MEMORANDUM

SUBJECT: Valley's Edge Specific Plan Draft EIR- Section 4.9

“VALLEY’S EDGE” SPECIFIC PLAN MIXED-USE DEVELOPMENT

Amended Drainage Report Addendum #1

Exhibit: Proposed
Detention (R5R6)
December 13, 2021

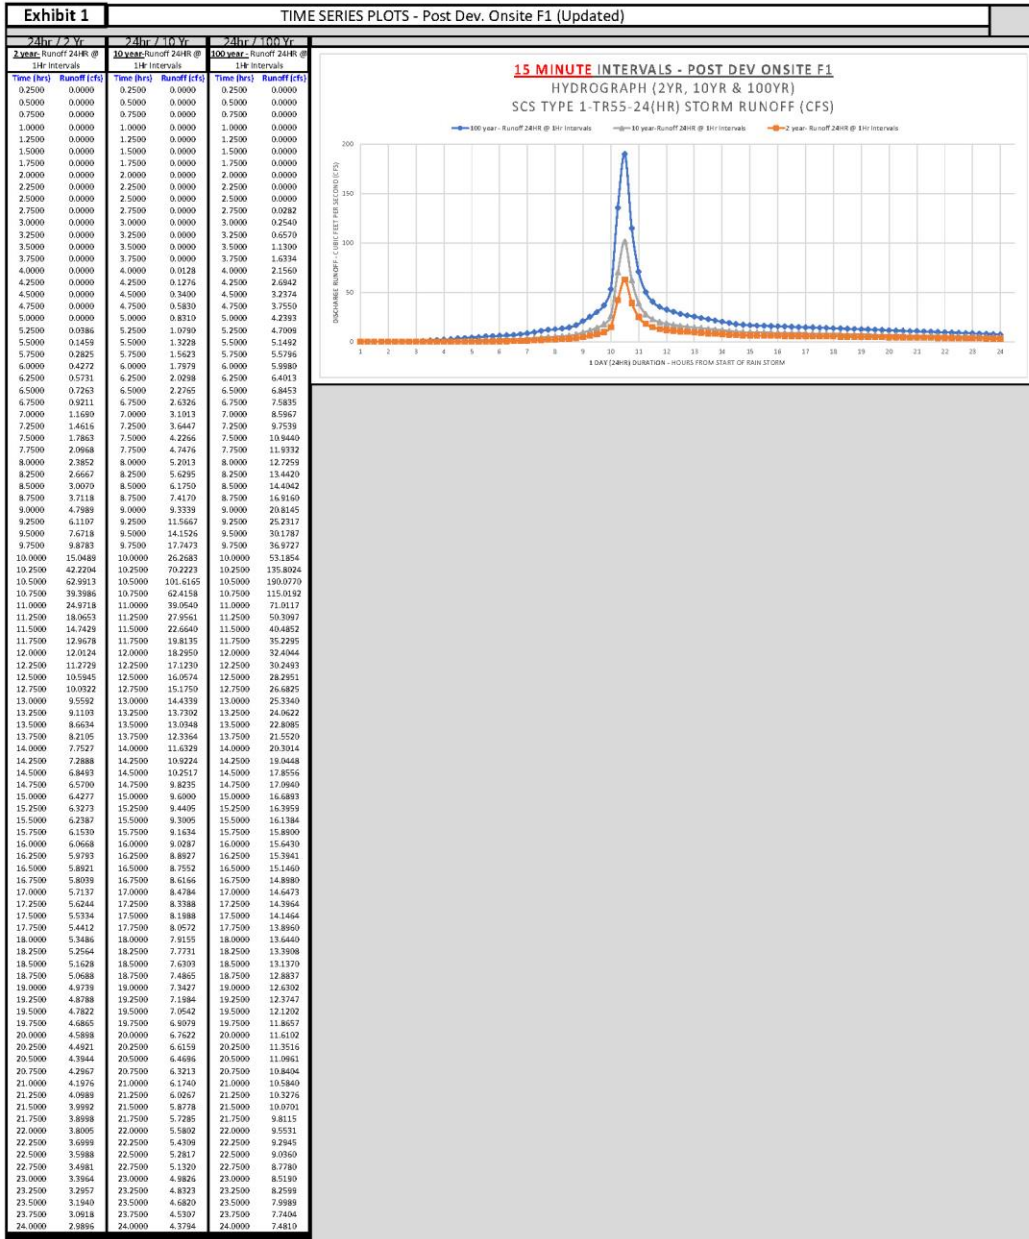
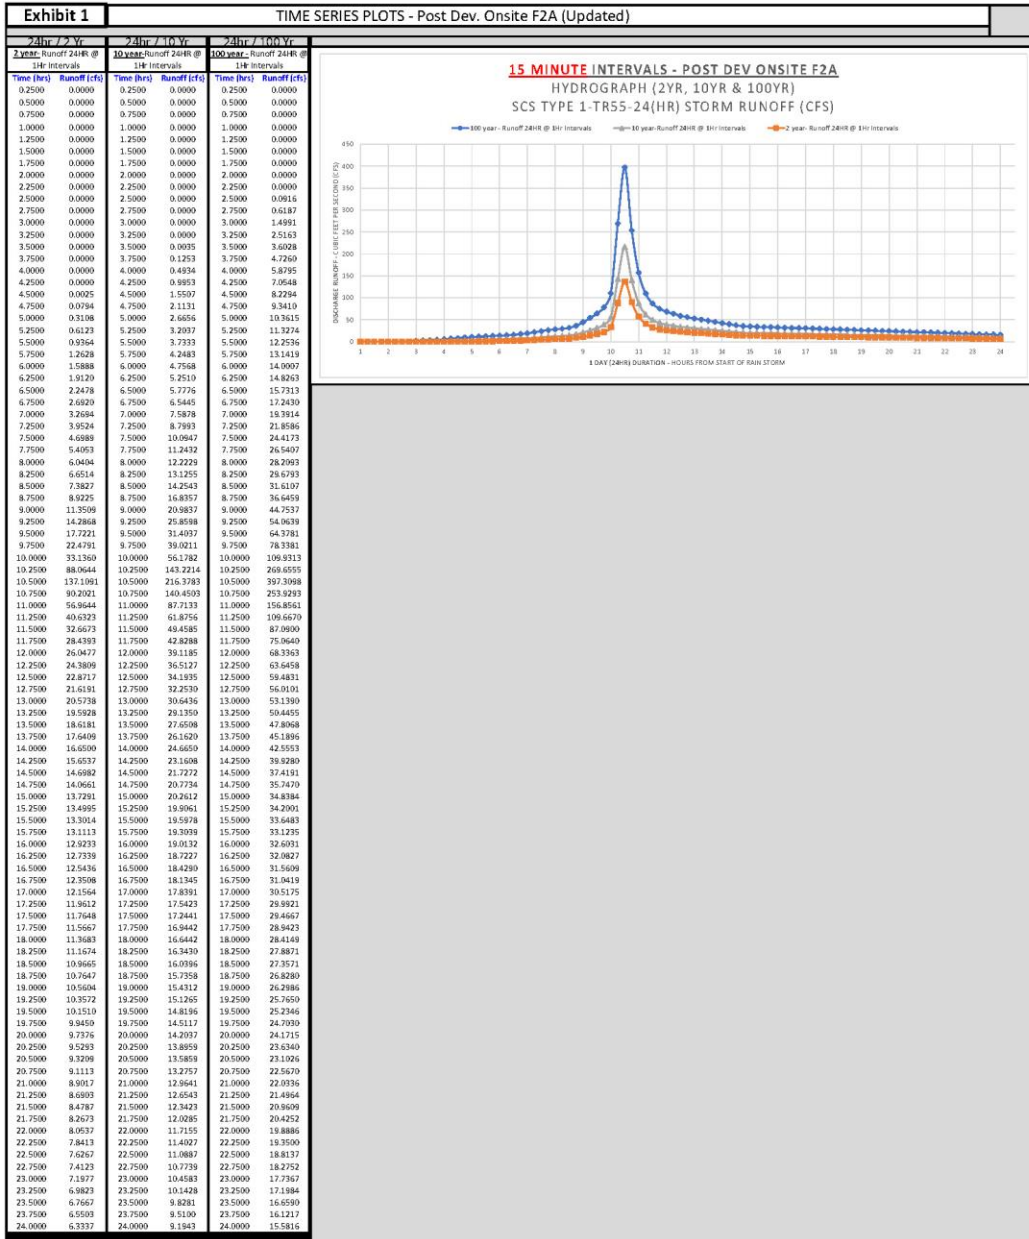
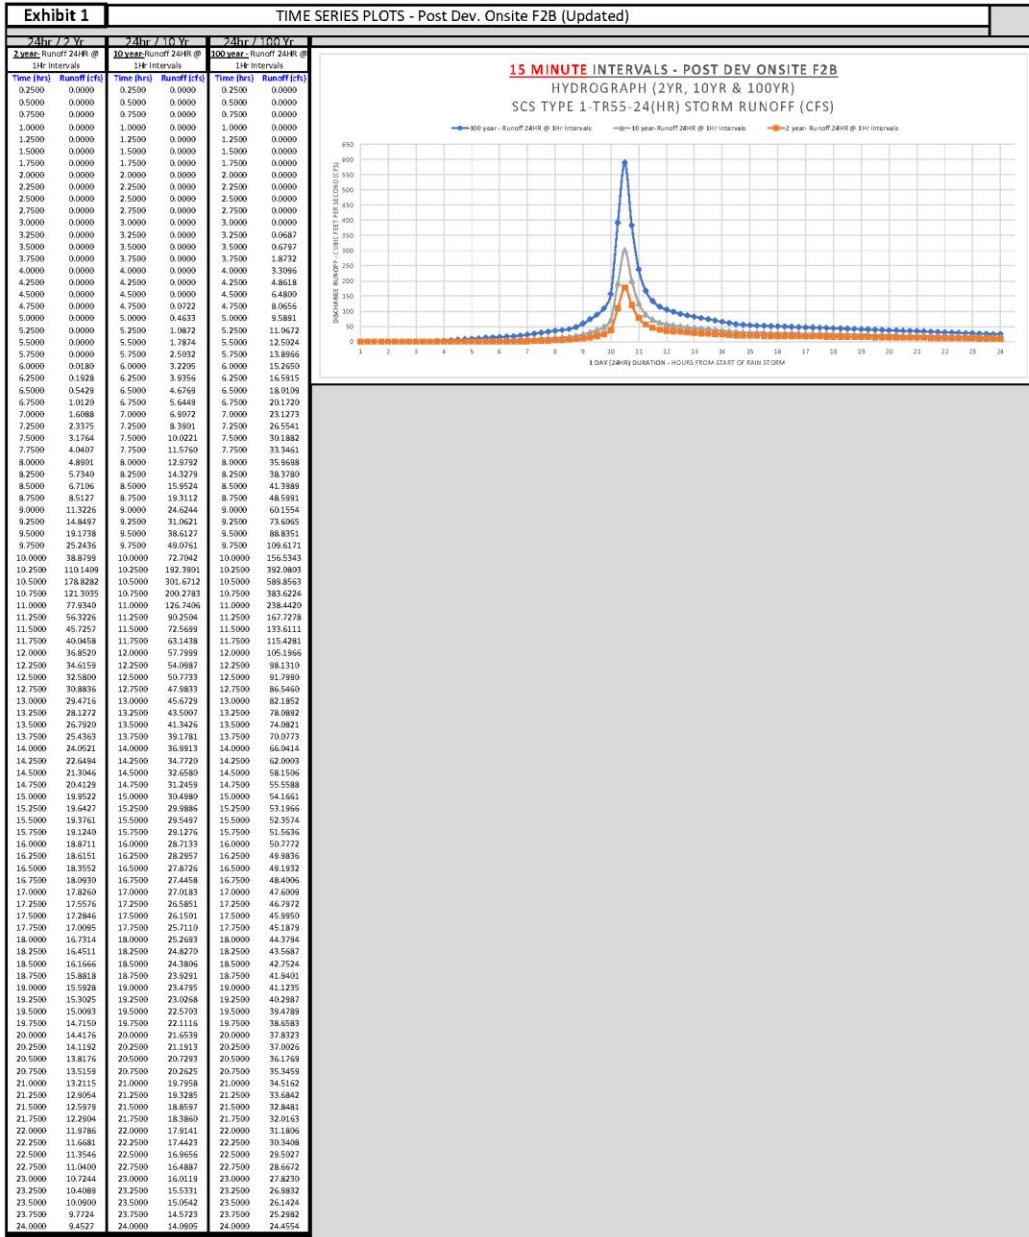
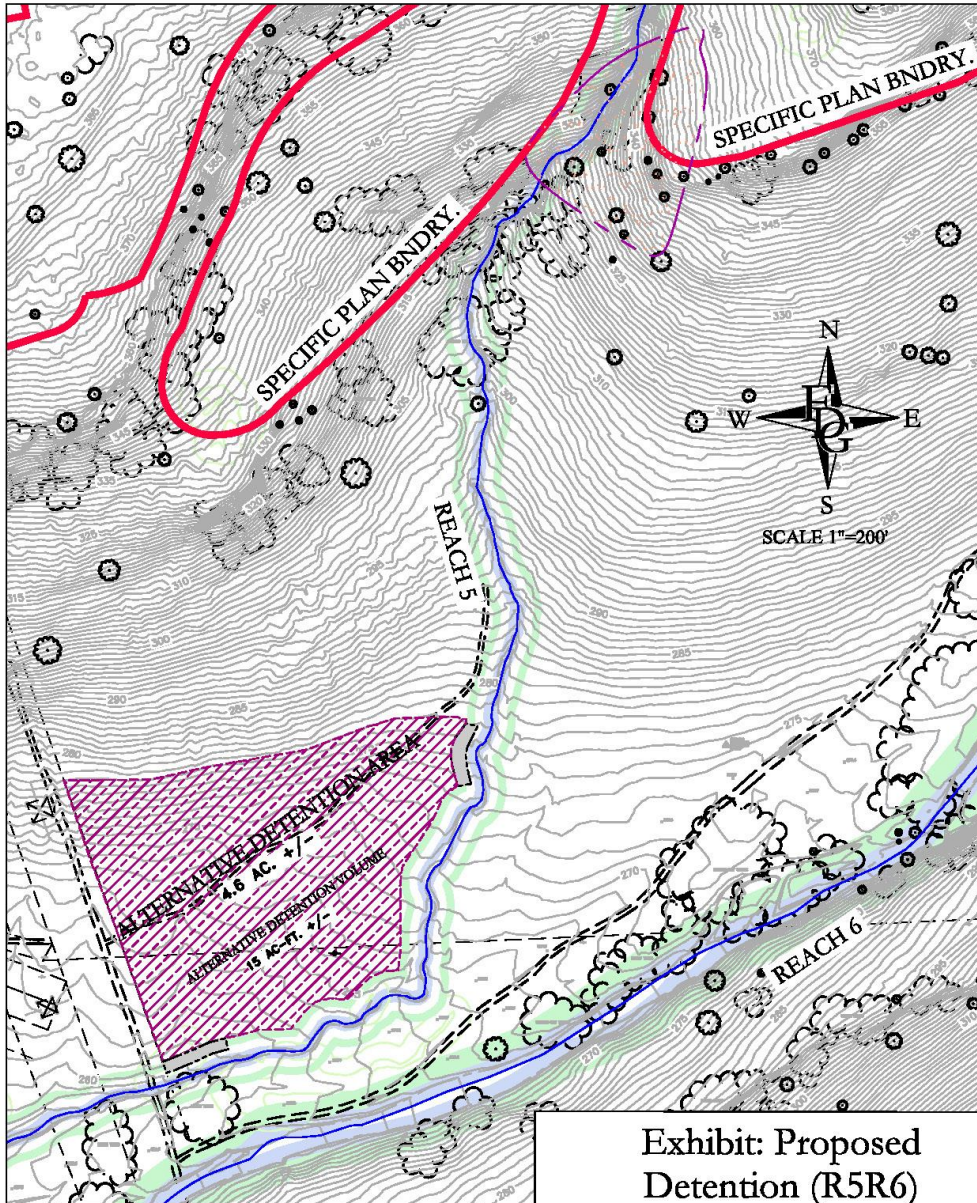
- 1) On Figure 4.9-3 – Proposed Reach R5 Detention Basin; we recommend that the alternative detention volume be changed from 10 ac-ft to 15 ac-ft. This is based on "Drainage Report Addendum #1," which was prepared by Frayji Design Group on September 14, 2021 and provided to the City. This report has been amended as of 12/13/2021 to rectify any unclear language regarding development area within reach 6. (attached hereto)

- Replace 7.5-acre-foot detention with 15-acre-foot detention under subsection "Reaches 5 and 6." And it should also be made clear that this detention is being proposed for both Reaches R5 and R6. This detention basin is sized to offset any increases from the development within Reach 5 and Northeast of Reach 6. The Development South of Reach 6 is very low density and based on the type of development we do not anticipate increased flow when comparing existing conditions to proposed conditions.

- We recommend removing all statements that detention is only required for Reach R5. Our initial study assumed detention by virtue of culvert downsizing along the road connecting the development to Honeyrun. The Memo provided in September 2021 provided the needed detention to offset any increases of runoff by the development if the roadway is not constructed. See attached amended report dated 12/13/2021 (attached hereto)

- 35-2** The comment requests that Figure 4.9-3 (Draft EIR p. 4.9-37) be updated to indicate that the Reach R5 Detention Basin is 15 acre-feet, rather than 10 acre-feet. The comment also indicates that *Drainage Report Addendum #1* was updated to clarify unclear language regarding the proposed development area within Reach 6.

Figure 4.9-3 has been updated in response to the comment and the *Amended Drainage Report Addendum #1*, dated December 13, 2021, has replaced Appendix H-5. Page 4.9-1 in Section 4.9 of the Draft EIR has been edited to accurately reflect the appendices in the Final EIR. Please see Chapter 3, Changes to the Draft EIR for the revised figure, updated Drainage Report and other revisions to the text of the EIR. These changes do not alter the conclusions of the Draft EIR. With respect to clarifying language regarding Reach 6, please see Response to Comment 35-4 below.
